**FARRAGUT VISUAL RESOURCES REVIEW BOARD
AGENDA**

Farragut Town Hall
Board Room
Tuesday, February 22, 2022
7:00 p.m.

MEMORANDUM

TO: Farragut Visual Resources Review Board
FROM: Bart Hose, Assist. Community Development Director.
SUBJECT: Regularly Scheduled Meeting - Tuesday, February 22, 2022, at 7:00 p.m.

SITE LANDSCAPE PLAN

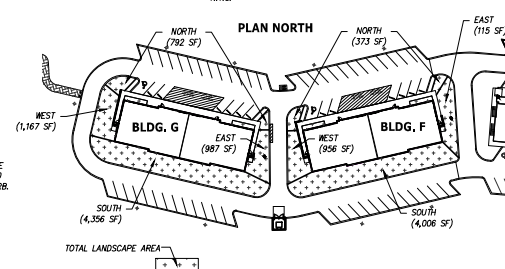
The applicant has revised the plan and addressed staff's initial review comments. The staff recommends plan approval.

REVISED PER TOWN OF FARRAGUT VIB COMMENTS	02/17/2022
REVISED PER TOWN OF FARRAGUT COMMENTS	02/07/2022
